**JEA Brandy Branch
Combined Cycle Conversion**

**JEA-Brandy Branch
Sufficiency Response**

Re: JEA-Brandy Branch Conversion Project
Site Certification Application
FDEP File No. PA 00-43
DOAH Case No. 00-5120EPP
OGC Case No. 00-2321
Response to Statement of Sufficiency

Preconstruction Land Use and Cover Brandy Branch Generating Station

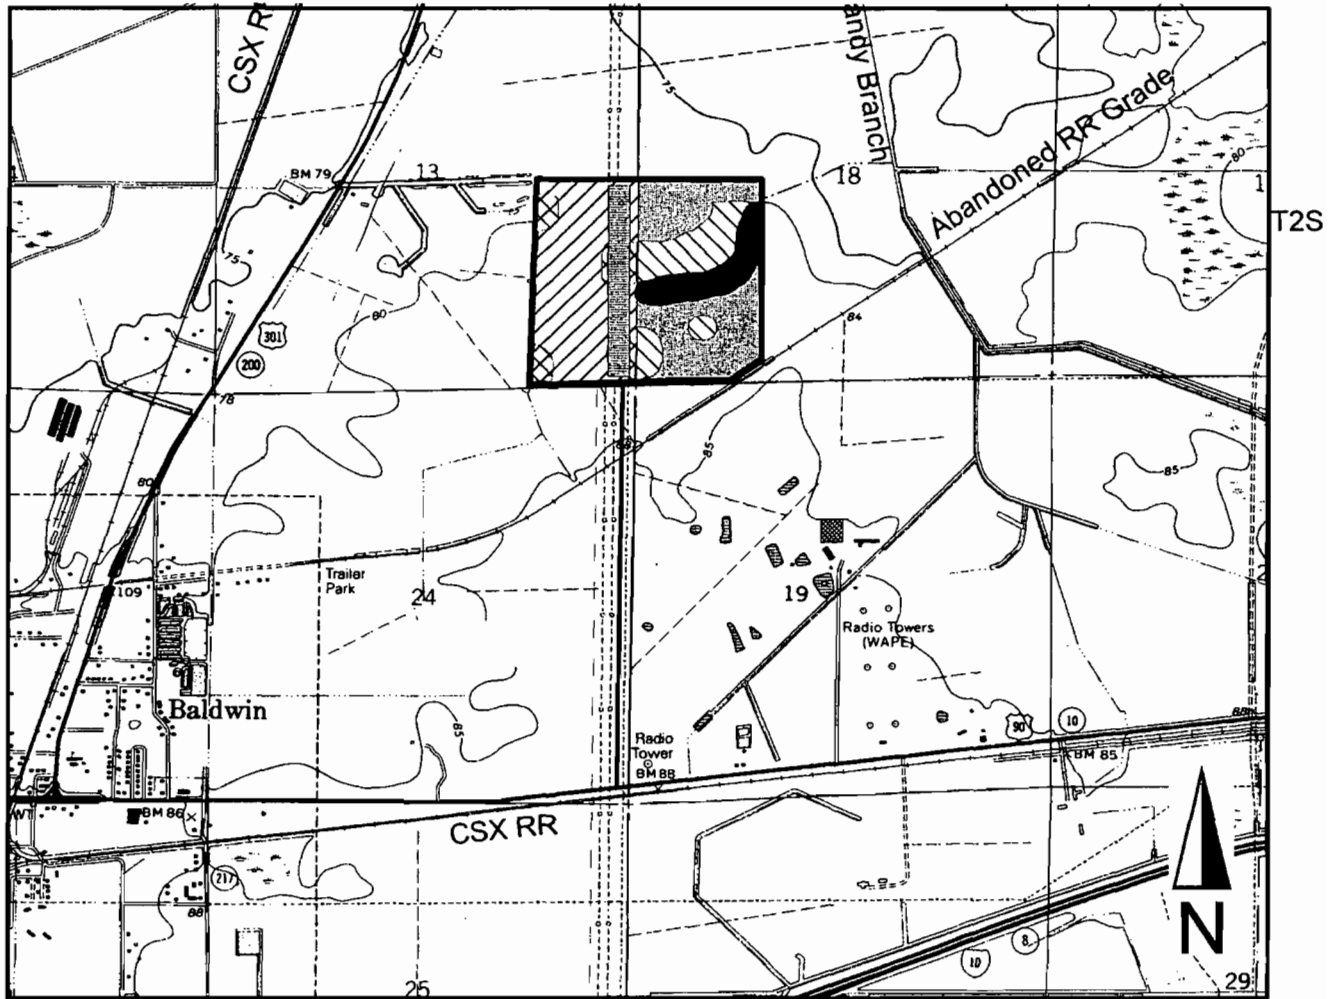
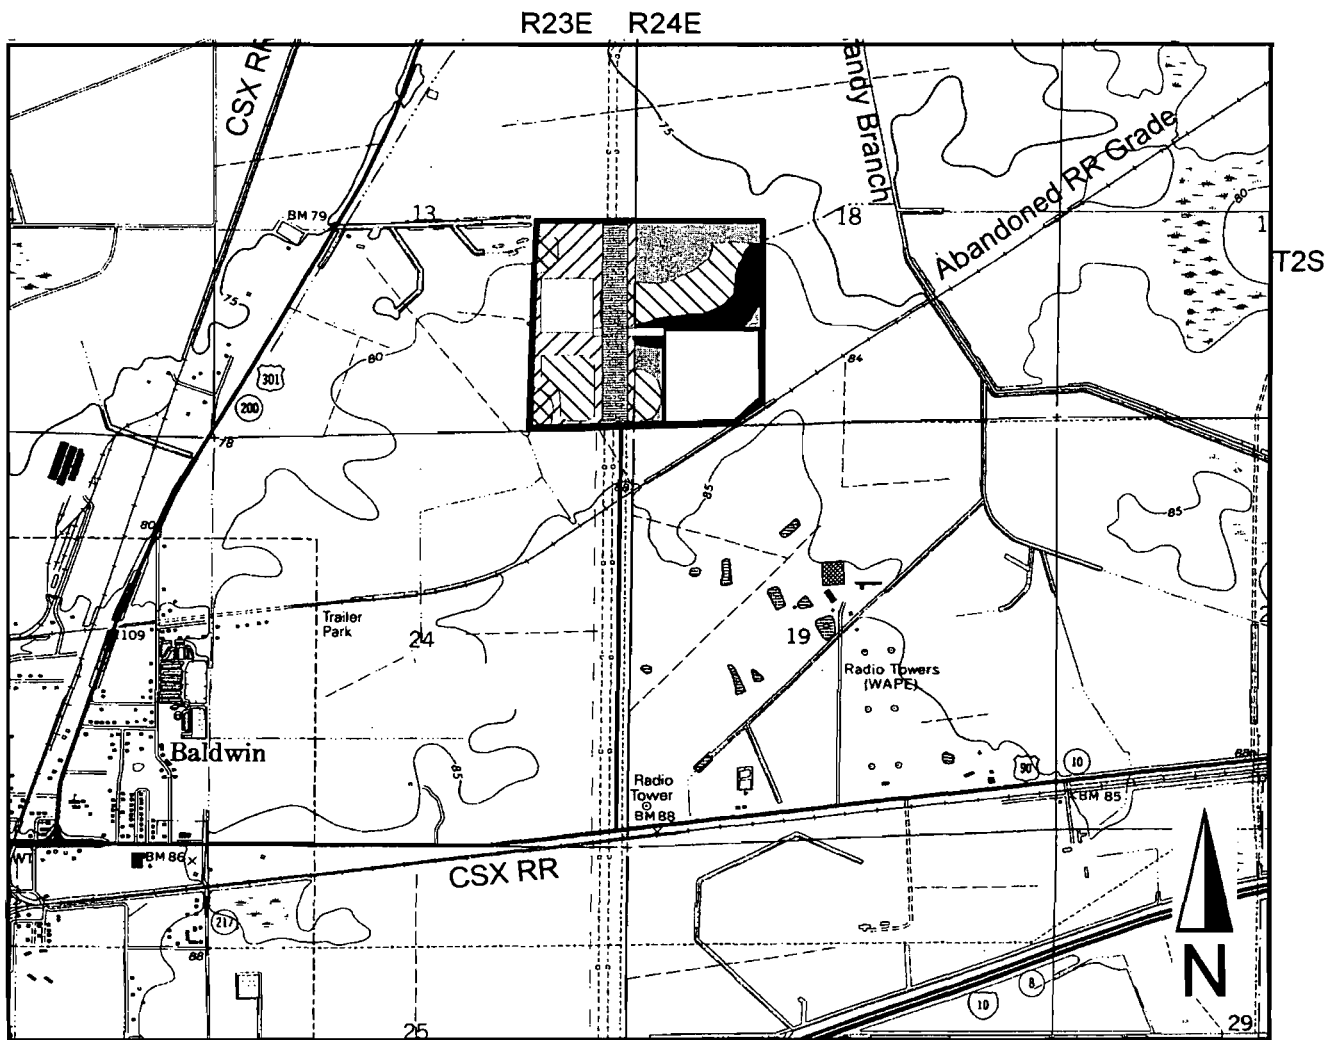
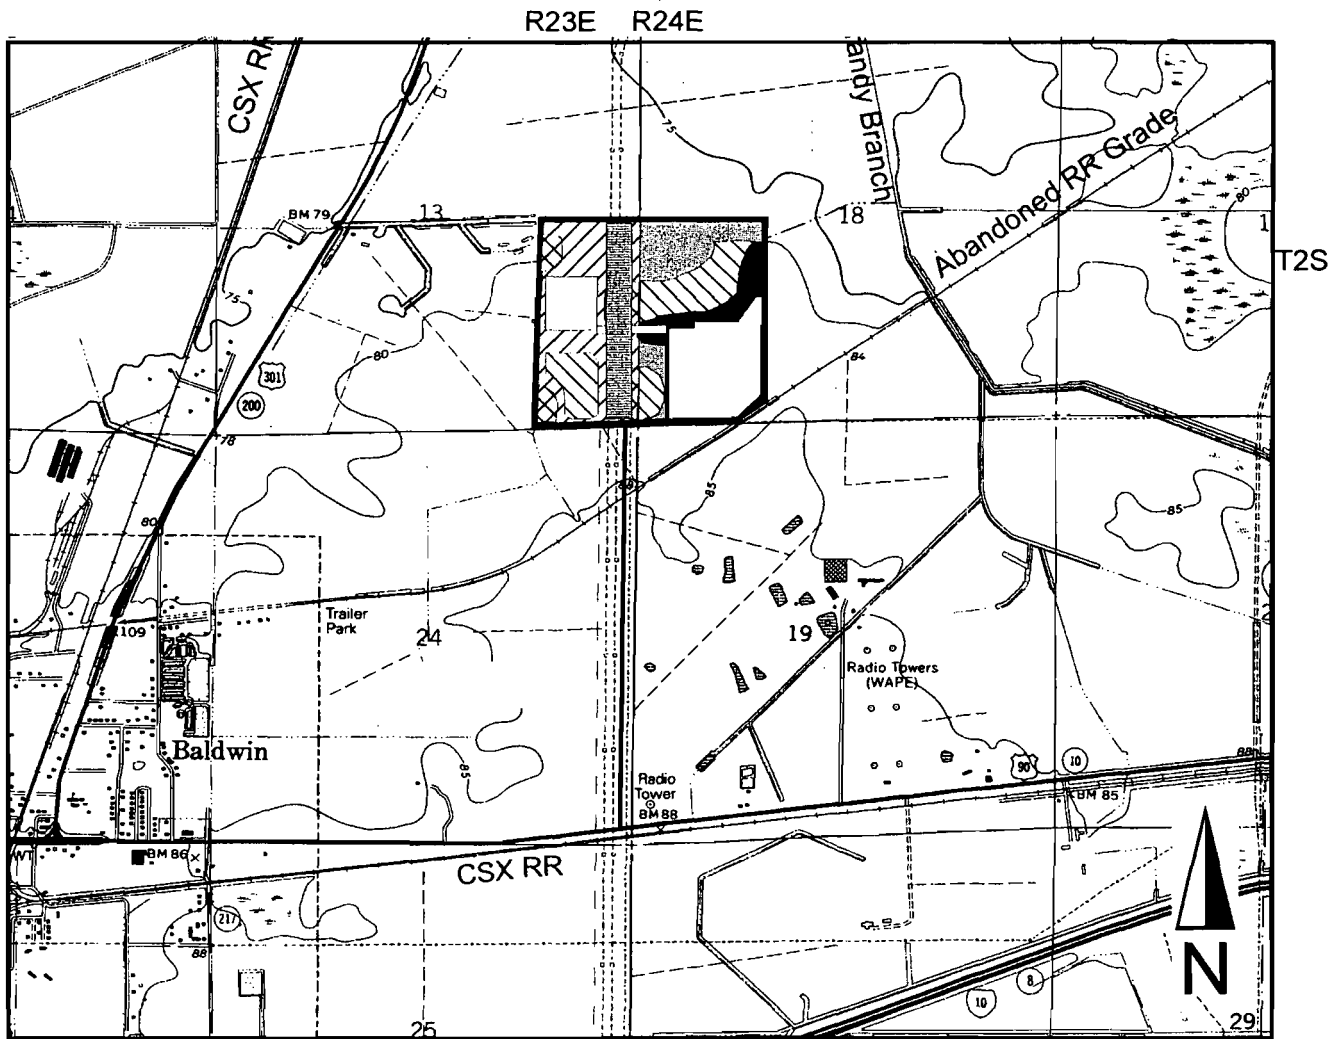
1. *In reviewing the site application, it was difficult to determine what the current conditions of the site are, or how much of the site has already been altered for construction of the first three units. The descriptions of vegetative communities of the site apparently were prepared prior to the current construction activities, and do not describe what will be impacted by this conversion project. The application mentions an additional 2.5 acre area of pine woods to be cleared, but does not provide any detail about this area. The applicant should provide a vegetation map showing current vegetative cover, with the footprints of new facilities needed for the conversion project clearly indicated.*

Response: Pre-construction land use / vegetative cover for the Brandy Branch Generating Station site is illustrated in Figure 1. Actual land use / vegetative cover for simple cycle construction of the Brandy Branch Generating Station site is illustrated in Figure 2. Figure 3 represents the proposed land use / vegetative cover for combined cycle construction of the Brandy Branch Generating Station site.

Construction of the simple cycle facility began in November 1999. To date, all areas (42 acres) scheduled for construction have been fully developed. Please note the additional combined cycle construction area in the northeast corner of the power block area for the cooling tower and associated piping. A more detailed view of this locality showing the plant footprint and additional construction area is illustrated in Figure 4. An additional total of 2.96 acres of conversion / cooling tower impact are expected at the location, with 2.5 acres composed of pine flat woods and 0.46 acres composed of coniferous plantation.

Hydro-stratigraphic Cross Section at JEA Brandy Branch Site

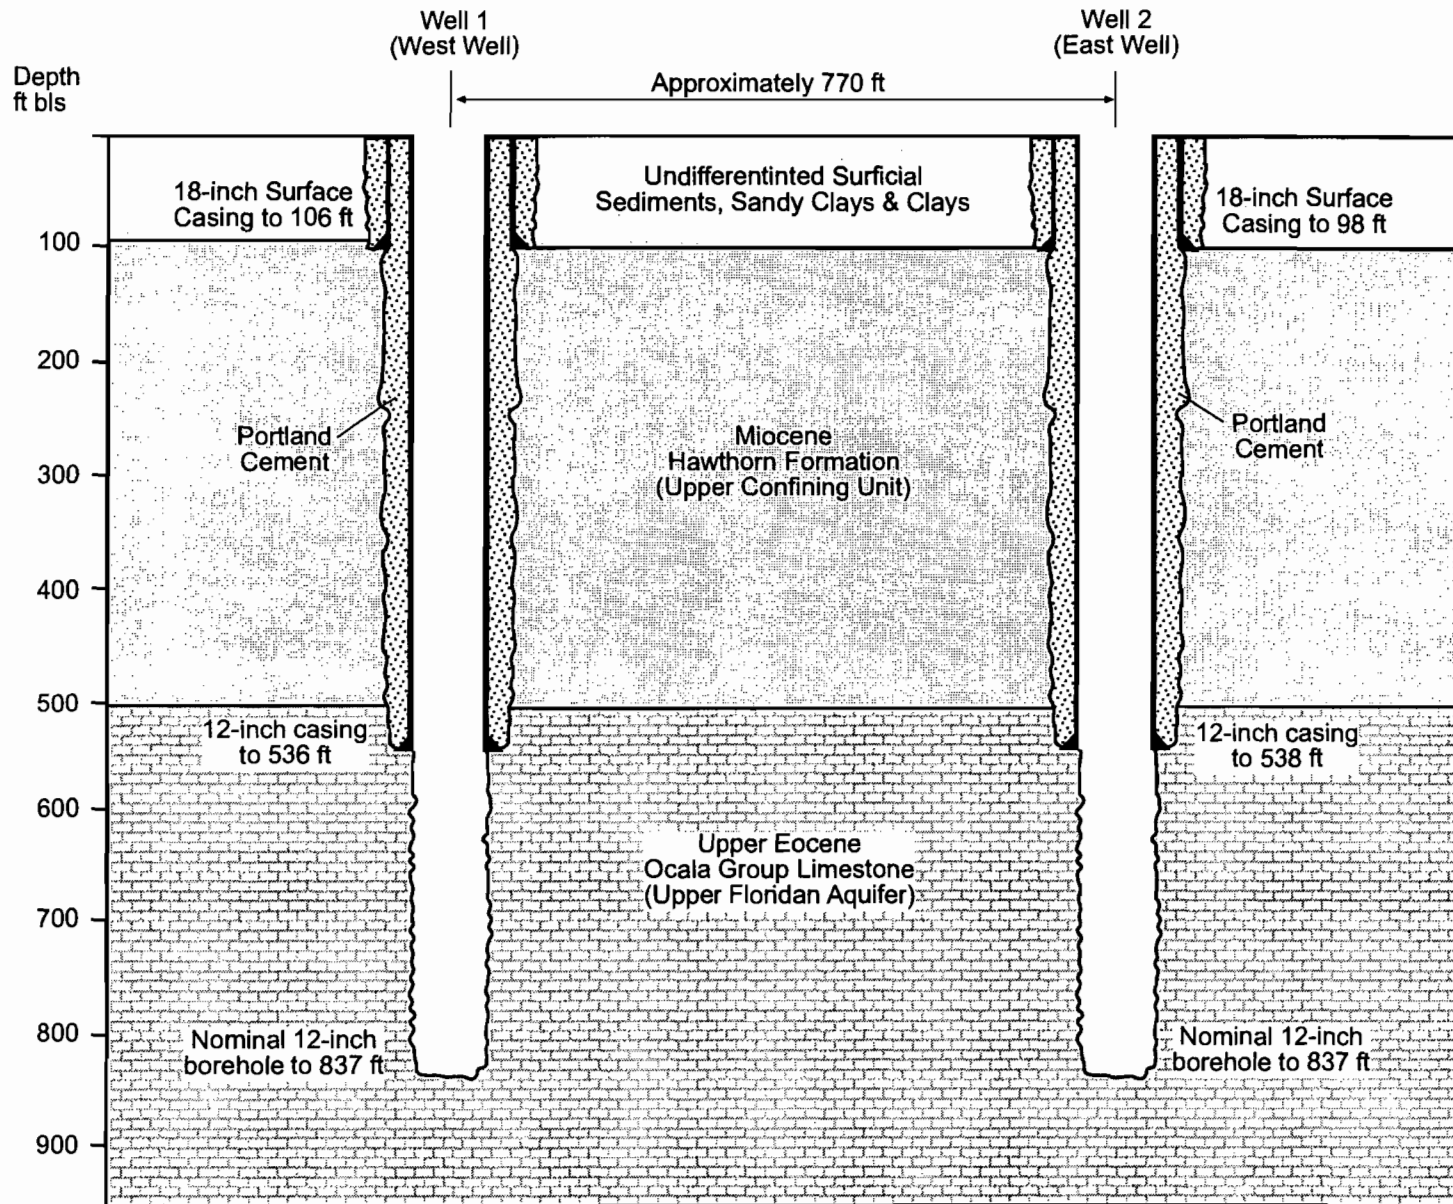
1. *The application indicates that there are herbaceous and forested wetlands as well as other surface waters on and surrounding the proposed site. The ground water modeling, however, analyzes the drawdown impacts to the Floridan aquifer only. Please provide an analysis of the steady-state impact of the proposed Floridan aquifer withdrawals on the surficial water table at the maximum proposed pump rate of 2.744 million gallons per day (mgd) and at increased rate of 3.722 mgd for 288 hours, transient conditions. The drawdown contours should be overlain on a map of wetlands and surface waters and displayed at one-half foot intervals and also delineate outward from the well(s) to the 0.2 foot drawdown contour. [Section 10.2(e)(f)(g)(l)(p), 10.3(d), Applicant's Handbook Consumptive Uses of Water (February 8, 1999) (A.H.)]*

Response: Exhibit 1 shows a hydro-stratigraphic cross section at the site with the completion details of the new production wells. The data collected during the pumping tests of the "east" well in May and June of 2000 was reviewed. During the test, a transducer was set in the shallow aquifer "rock" zone temporary water supply well at the site. The shallow rock zone well was located several hundred feet west of the pumping well and was completed into the carbonate rock at the base of the shallow aquifer approximately 100 feet in depth. Exhibit 2 shows the depth to water in this well during the constant rate test of the "east" Floridan aquifer water supply well. No obvious correlation in water level change is apparent. Although there is a general downward trend of about 0.05 feet during the 48-hour test, the trend continues through the recovery phase of the pumping test. If the water level drop were related to pumping the underlying Floridan aquifer, the water levels in the shallow rock well would have recovered when the pump was shut off. The trends noted on Exhibit 2 were likely caused by variations in barometric pressure and changes in local domestic demand. This shallow rock aquifer is used in this area for domestic supply purposes.
